Product Change Notification - SYST-19TBKO462

ERRATA - dsPIC33FJ06GS101/X02 and dsPIC33FJ16GSX02/X04 Family Silicon Errata and Data Sheet Clarification

Description of Change: 1) Added new silicon issue 52 (PWM). 2) This revision shows modified bit representation (e.g., bits<3:0> have been changed to bits[3:0]). This is done to be consistent with documents that were created in the SDL software.

dsPIC33FJ06GS101/X02 and dsPIC33FJ16GSX02/X04 Family Silicon Errata and Data Sheet Clarification

FIGURE 1: TIMING DIAGRAMS FOR CENTER-ALIGNED AND EDGE-ALIGNED MODES

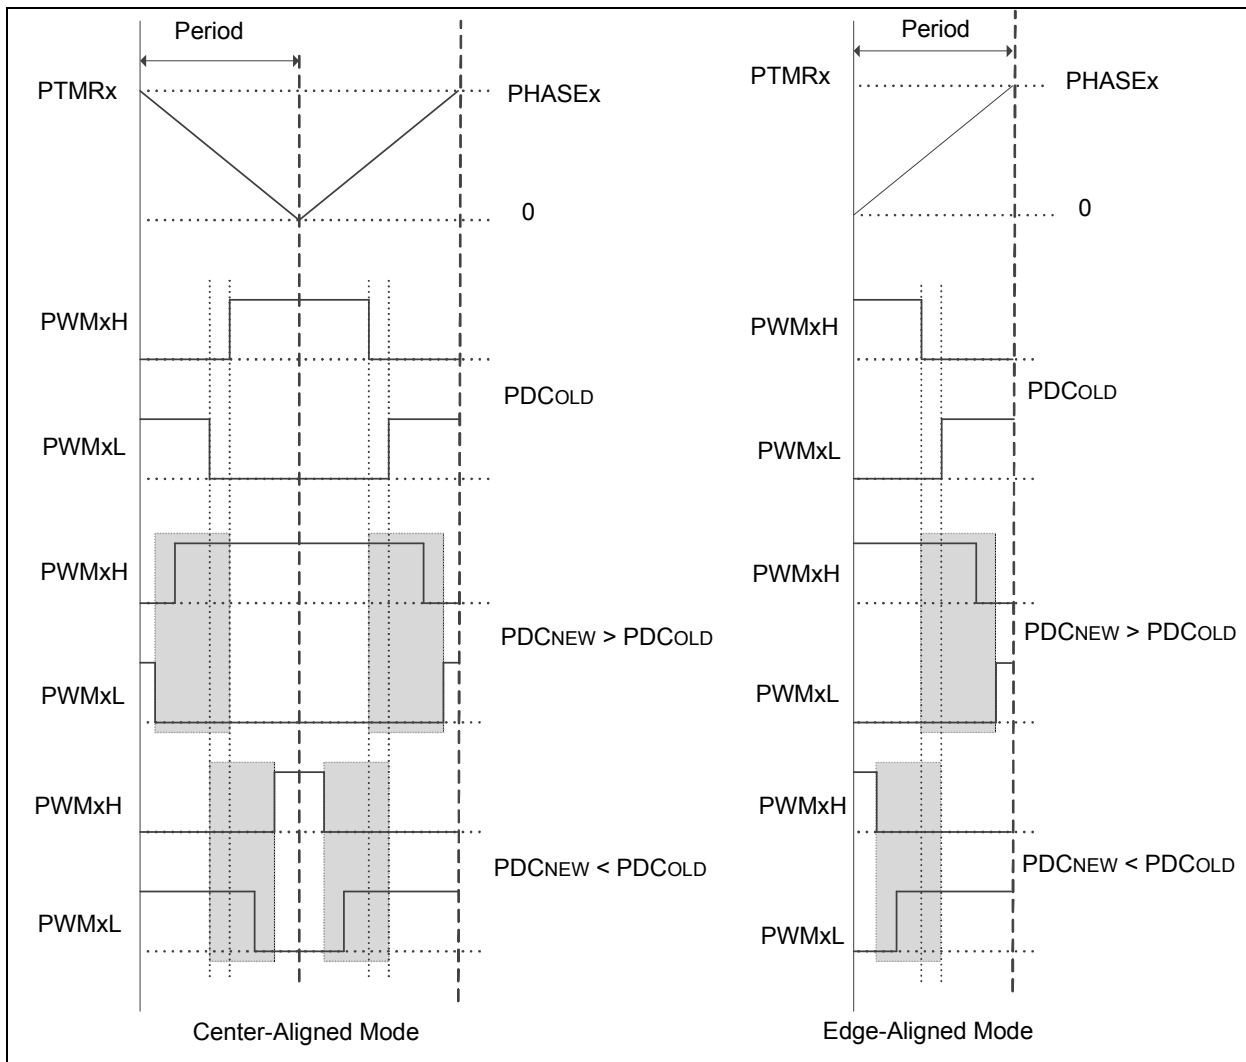
In [Figure 1](#) (following page), if the duty cycle write occurred in the shaded box, then PWMxH and PWMxL will make an immediate transition without dead time.

FIGURE 2: ISSUE EXAMPLE FOR REDUNDANT OUTPUT MODE

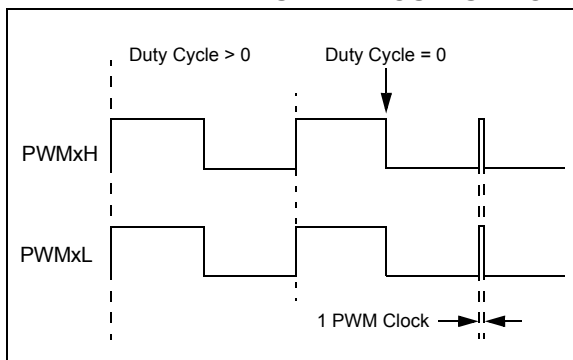
In Redundant Output mode (IOCONx[11:10] = 01) and Push-Pull Output mode (IOCONx[11:10] = 10), with the Immediate Update disabled (PWMCONx[0] = 0), when the Duty Cycle register is updated from a non-zero value to zero, a glitch pulse of a width equal to 1 PWM clock will appear at the next PWM period boundary, as shown in Figure 2 (for the Redundant Output mode). The Duty Cycle register refers to the PDCx register if PWMCONx[8] = 0 or the MDC register if PWMCONx[8] = 1.

52. Module: PWM

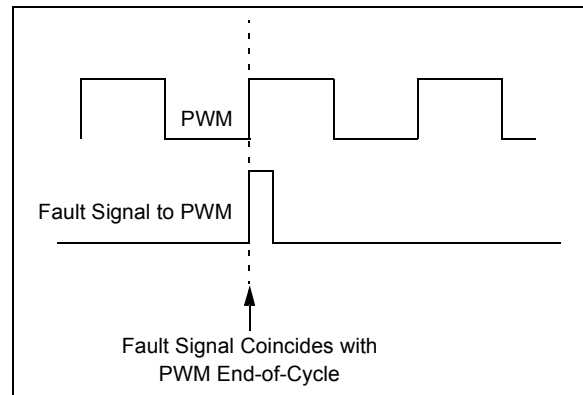
When the PWM module is operated in Complementary, Redundant, Push-Pull or True Independent Output modes and the PWM Fault/Current-Limit Fault are configured to provide a Fault event to the PWM, under certain conditions where the Fault event active edge happens to coincide with the PWM End-of-Cycle (EOC) event, the PWM fails to recognize the Fault event.
